Joshua Young
Air Safety Investigator
AS-ERA

Subject: ERA23LA365, Memorandum for Record - Electric Fuel Boost Pump
Location Revision

Date: 9/26/2023

Subject: ERA23LA365, Electric Fuel Boost Pump Location

Photo 1: View of the correct drawing 31_8

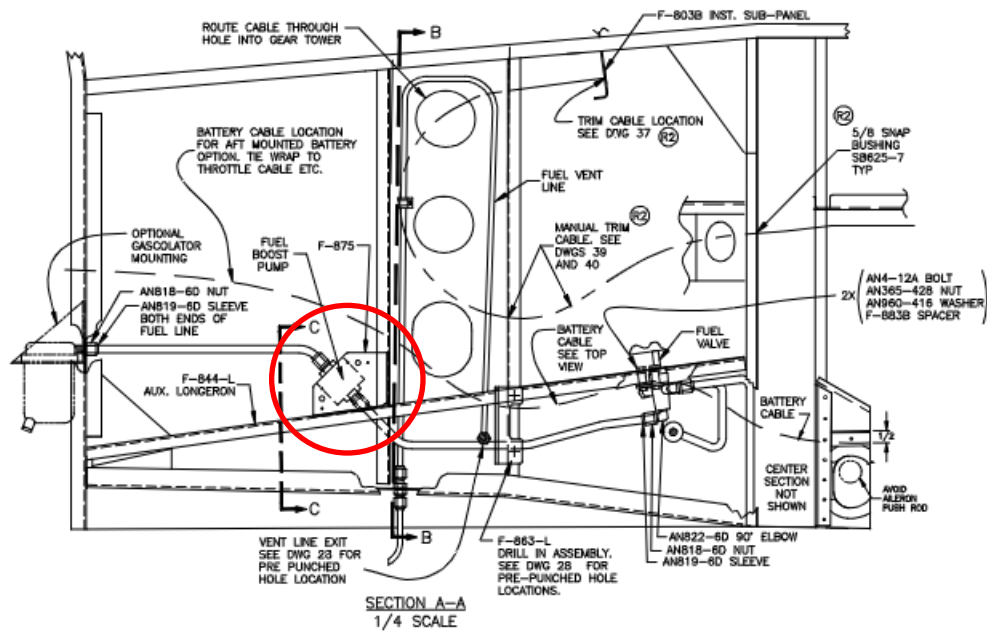
The builder of the aircraft contacted the IIC via electronic mail on October 30, 2024, and reported that he believed there was an error in the NTSB final report which stated, "Photographs from the FAA inspector of the electric fuel boost pump indicated it was not installed on the airplane according to the kit manufacturer's build plan." He included a photograph of the build plans used when the aircraft was manufactured and photographs of the installation of the fuel boost pump. Upon review of this documentation the IIC found that in the original memorandum dated 9/26/2023, below, an incorrect drawing from the manufacturer was used. The drawing used was for the correct airframe but was drawn in January of 2006, Van's Aircraft RV-8 drawing 82_8, and would not have been available to the builder during the construction of the airplane which was completed in 2005. Upon further review of the manufacturer's drawings, it was found that the builder installed the fuel boost pump correctly in accordance with the build instructions available at the time, Van's Aircraft RV-8 drawing 31_8.
